**CONTRACTING AUTHORITY'S CLARIFICATIONS No. 1**

**“Refurbishment and improved safety conditions of Children playgrounds”**

**Publication ref.: EuropeAid/139442/IH/SUP/RS**

Location of playground in Kragujevac, Trg Slobode

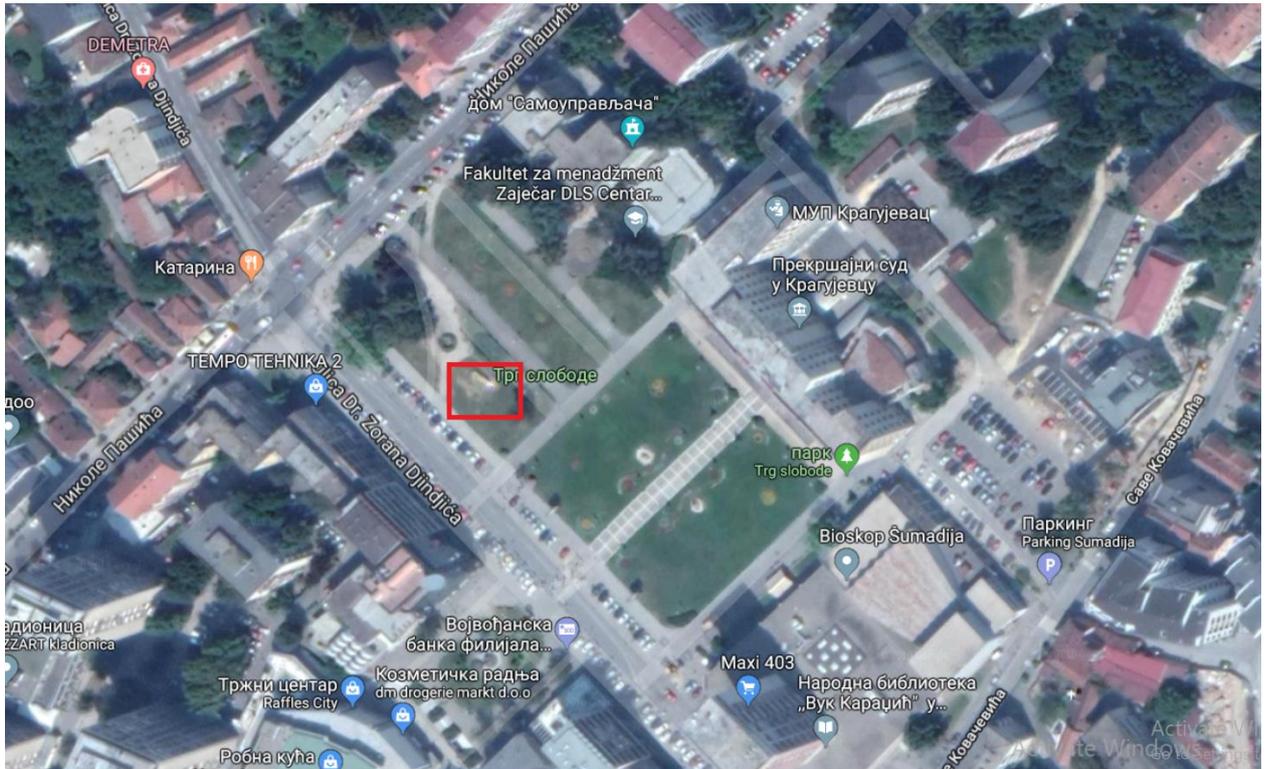
17.	During our site-visit, we were not able to find some playground areas,since on the layouts there were no Street names such as;  <ul style="list-style-type: none"> <li>• Velika Krsna,</li> <li>• Milice Stojadinovic</li> <li>• Kragujevac etc.</li> </ul>	Please, see ANNEX below.

Could you please send specific locations?	
--	---	--
